PRODUCT/PROCESS CHANGE NOTICE (PCN)

PCN #: TB-0609-03	DATE: 06-Oct-2006	MEANS OF DISTINGUISHING CHANGED DEVICES:
Product Affected: All square PQFP and TQFP, MLP Dual, QFP-N, VFQFP-N packages shipped in Tape and Reel		☐ Product Mark ☐ Back Mark ☐ Date Code ☒ Other
Date Effective: 06-Nov-2006		Starting 06-Nov-2006

ATTACHMENT I - PCN #: TB-0609-03

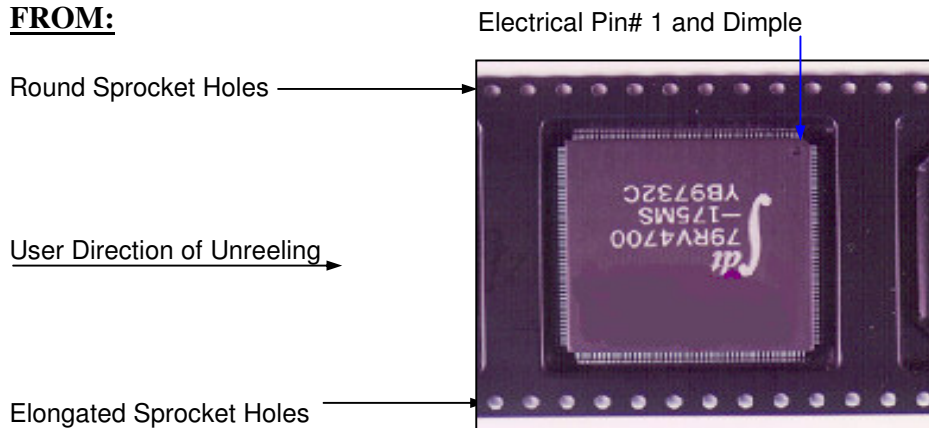
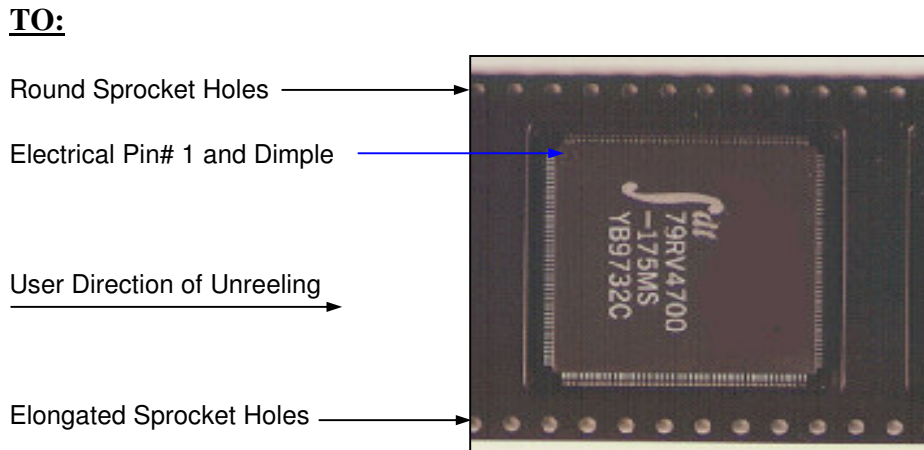
| ☐ Die Technology | Pin 1 orientation of all square PQFP and TQFP, MLP Dual, QFP-N and VFQFP-N packages shipped in Tape and Reel packaging will be changed to comply with current EIA Standard (EIA-481-C) requirement. |

Detail of Change: This change will be implemented on all square PQFP and TQFP, MLP Dual, QFP-N, VFQFP-N packages.

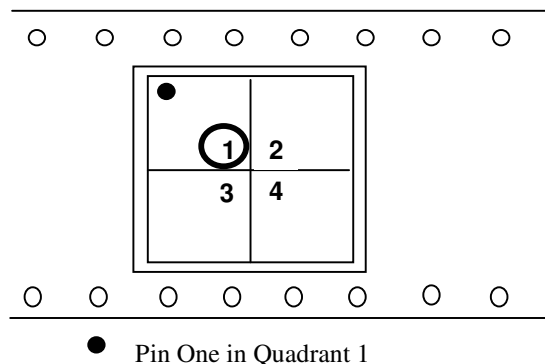
Additional label as shown below will be placed on the intermediate box (pizza box) to alert customer of this change. Label will be placed starting 06-Nov-2006 until 06-Nov-2007.
